## SERVICE BULLETIN

REFERENCE ENGINE \_\_\_\_\_  
NUMBER 009 \_\_\_\_\_  
DATE 08-18-89 \_\_\_\_\_  
MODEL AW16 \_\_\_\_\_

### OIL COOLER HOSE REVISION - SUPERCHARGED MR2

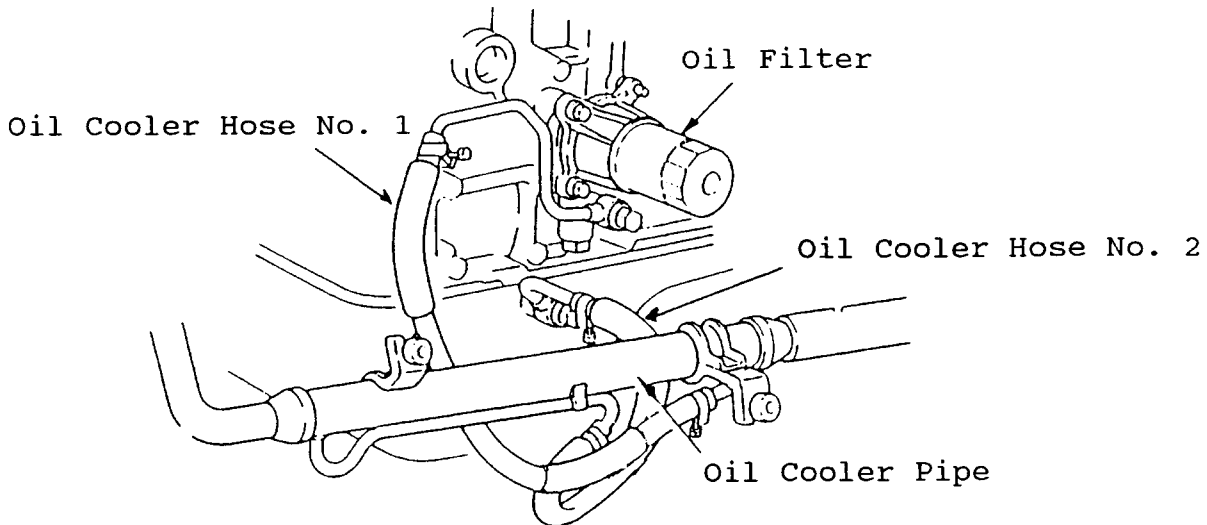
The length of oil cooler hose No. 2 has been extended from 450mm (18") to 480mm (19") to ease installation of the hose.

NAME	PREVIOUS P/N	NEW P/N
Hose, Oil Cooler, No. 2	15778-16040	<b>15778-16060</b>

The new P/N should be used anytime this hose is replaced.
